STAFF REPORT
COMMUNITY DEVELOPMENT DEPARTMENT

DATE: 3/2/2021
 TO: Mayor & City Council
 FROM: Joseph Dodson, Associate Planner
 208-884-5533
 SUBJECT: FP-2020-0020
 Jocelyn Park No. 2

A final plat consisting of twenty-five (25) building lots and one (1) common lot on 3.26 acres of land in the R-8 zoning district. *This is the second and final phase for Jocelyn Park Subdivision (H-2020-0067).*

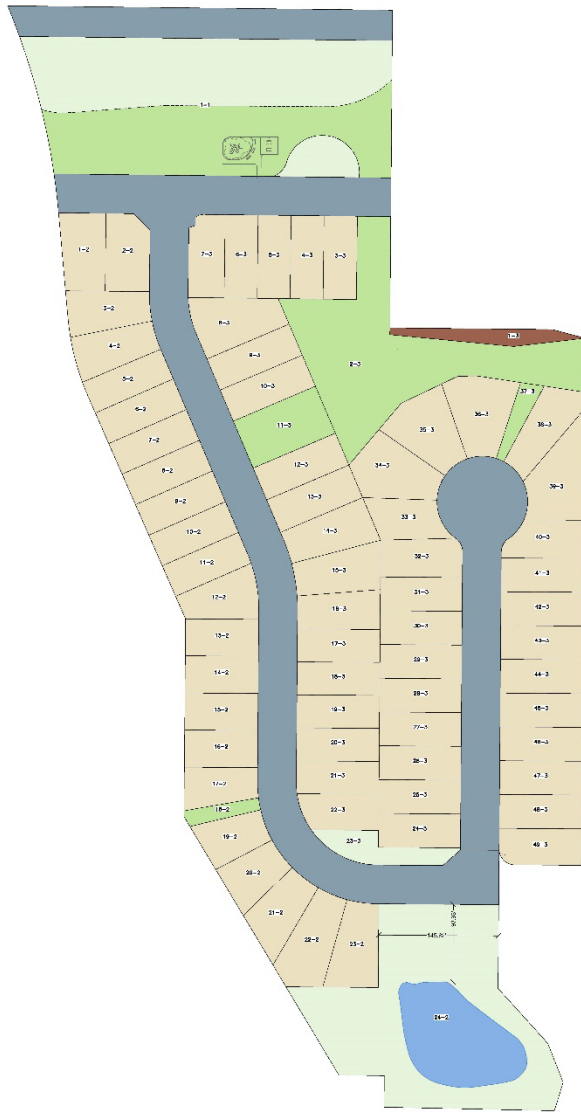
- a. Remove Note #10 as this development is not bound by a Development Agreement.
 - b. Note #11: Include recorded easement instrument number.
 - c. Note #13: Include the recorded instrument number and correct note number (should be Note #12).

- d. Widen the micro-path lot abutting the cul-de-sac to be at least 15 feet wide, in accord with UDC 113A-8; revise building lots as needed.
5. Prior to signature on the final plat by the City Engineer, the landscape plan prepared by Jensen Belts Associates (Exhibit C), dated December 18, 2020, shall be revised as follows:

- a. Revise the micro-path lot abutting the cul-de-sac in accord with the plat condition above.
6. The applicant shall comply with the submitted home elevations within the approved preliminary plat (H-2020-0067).
